Access Compliance Report

Public Rights-of-Way

(Curb Ramps)

Intersection ID: 30271	Main Street: FORTESCUE_DR	Cross Street: RAVANNA_DR	Location: S
ADA ID: DDA73FFEE2D8	Ramp Type: PerpDiag	Initial Pass/Fail: Fail	Overall Compliance: No
Severity Score: 33.75			
Codes/Mitigation Info/Possible Solution		Field Measurements/Component Compliance

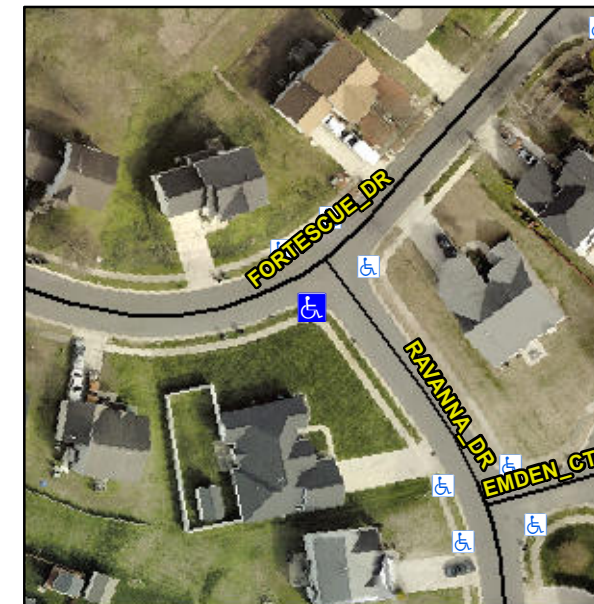
Not Found, R304.5.1, R304.5.3

Compliance	Description	Data	Compliance	Description	Data
N/A	Ramp Length (in)	50.0	Yes	Ramp Slope (%)	7.1
No	Ramp Width (in)	44.5	No	Ramp XSlope (%)	8.2
N/A	Flare Type LT	N/A	N/A	Flare Type RT	N/A
N/A	Flare Slope LT (%)	N/A	N/A	Flare Slope RT (%)	N/A
N/A	Flare Traversable LT?	N/A	N/A	Flare Traversable RT?	N/A
N/A	Landing Length (in)	N/A	N/A	DWS Provided?	N/A
N/A	Landing Width (in)	N/A	N/A	DWS Contrast?	N/A
N/A	Landing Slope (%)	N/A	N/A	DWS Length (in)	N/A
N/A	Landing X Slope (%)	N/A	N/A	DWS Full Width?	N/A
N/A	Landing Curb? (Y/N)	N/A	N/A	DWS Offset (in)	N/A
N/A	Shared Landing?	N/A			
N/A	Gutter Ponding?	N/A	N/A	Gutter Slope (%)	N/A
N/A	Gutter Lip Ht (in)	N/A	N/A	Gutter X Slope (%)	N/A
N/A	Painted X Walk1?	No	N/A	Painted X Walk2?	No
	X Walk 1 Direction	To E		X Walk 2 Direction	To W
N/A	X Walk 1 Width (in)	N/A	N/A	X Walk 2 Width (in)	N/A
	X Walk 1 Slope (%)	4.2		X Walk 2 Slope (%)	2.5
	X Walk 1 X Slope (%)	3.9		X Walk 2 X Slope (%)	3.7

Remove & Replace Curb Ramp With Two New Directional Ramps or Equivalent.
